Sales Selection Sheet

Wallaceton

LOT / UNIT 189A-2	PHASE 1	MODEL 20-1790 A The Dunmore	
----------------------	------------	--------------------------------	--

# Sketch #8

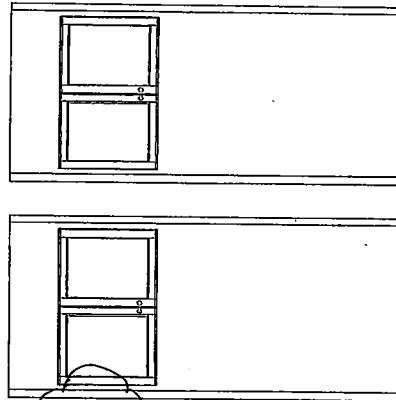
1 177,046 18,312	CABINETRY - CLASSIC PLUS - KITCHEN - UPGRADE 4  Note: AS PER IFSS 12 of 39 UPGRADE MISSED ON ORIGINAL SSC	Qty: 1
*2 189,247 18,314	CABINETRY - 21B-PULL-OUT SPICE RACK CABINET (FULL-HEIGHT CABINET RECEIVES [3] TRAYS, CABINET (40CM WIDE CABINETS) ; PRICE ALL THE SAME FOR ALL LINES - KITCHEN  Note: KITCHEN: TO BE INSTALLED BETWEEN THE POT AND PAN DRAWERS AND THE PANTRY SEE SKETCH # 8 PAGE # 42	Qty: 1
3 188,999 18,323	CABINETRY - 10B-UPGRADE LEVELS 1-4, 5-7 DRAWERS FROM METABOX TO TANDEMBOX PER DRAWER. BD X 4, BPP X  Note: KITCHEN: TO BE USED FOR PULL-OUT SPICE RACK SEE SKETCH # 8 PAGE# 42	Qty: 1
4 18,342	KITCHEN BANK OF DRAWERS  Note: KITCHEN: RELOCATE STD. BANK OF DRAWERS TO THE ISLAND SEE SKETCH # 8 PAGE# 42	Qty: 1

ADD 24" x 2'  
pantry

RELOCATE BANK  
OF DRAWERS
